Objection to proposed roof terrace at 1 Gladys Road (2021/0971/P)

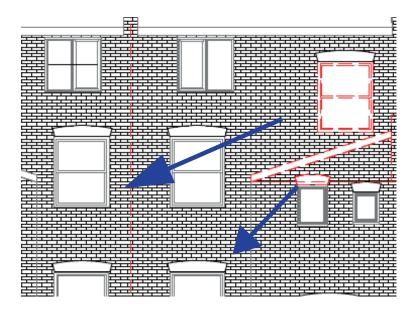
1.It would look directly into our kitchen area of our glass full ceiling. So we lose of privacy as upstairs have direct view into our kitchen and living space (ref1)

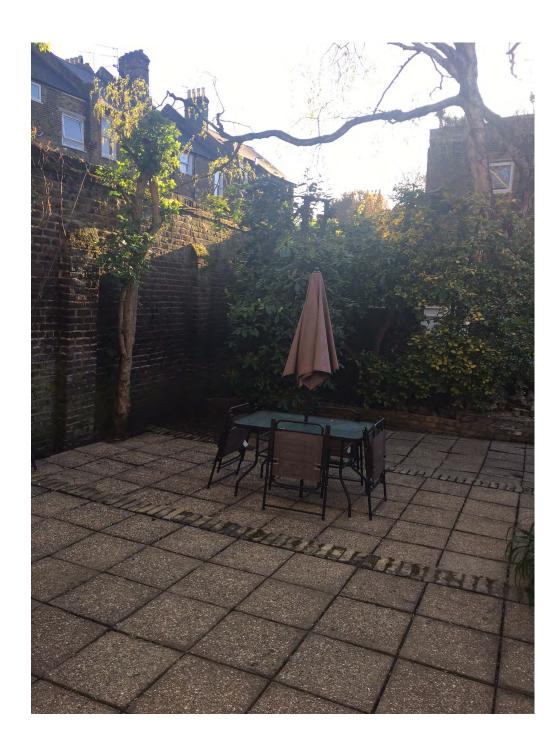
- 2. The impact of new uses of buildings and noise from people using the terrace would be above our bedrooms. The proposed terrace would have direct view into the bedroom, creating no privacy for the downstairs flat. Camden Planning CPG1 states roof level terraces should not result in overlooking of habitable rooms, the roof terraces does this. (ref 2)
- 3. Light Planning Daylight and Sunlight. We would require to shut our curtains in our bedrooms to avoid loss of privacy..
- 4. Potential for noise disturbance given the very close proximity to 1st floor bedrooms. We had issues with previous tenants with noise, a terrace would create additional noise in a quiet family neighbourhood.

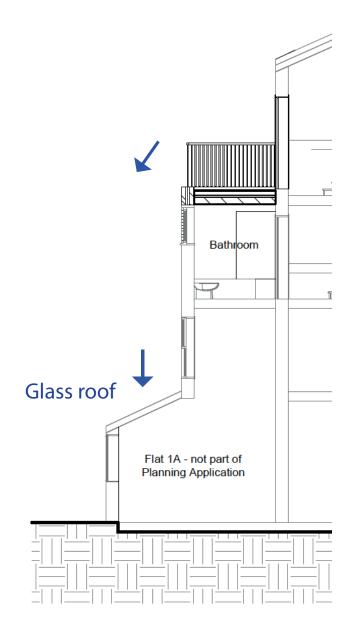
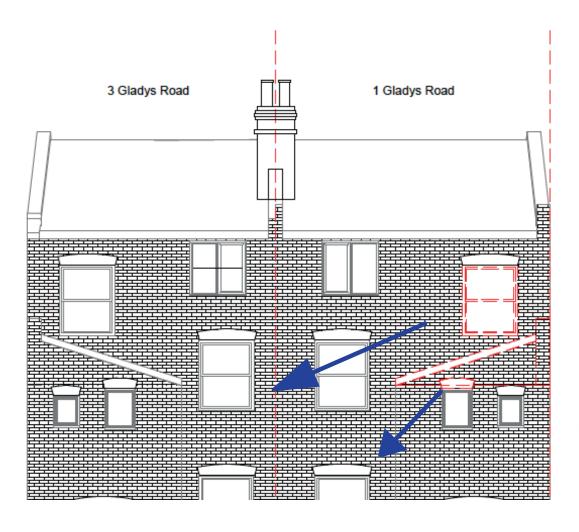
(2021/0971/P)
5. It would look directly in our garden giving our loss of privacy. (ref 5)

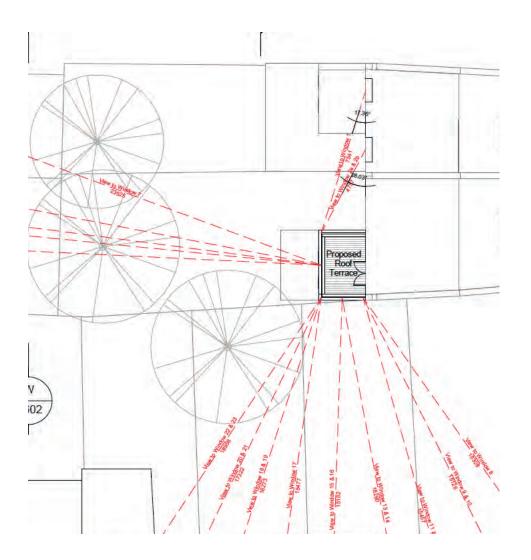
8. Work has already started, resulting in someone falling through the ceiling bottom flat where terrace woulid g.o We are concerned the structure not will not hold a terrace. (ref 8)
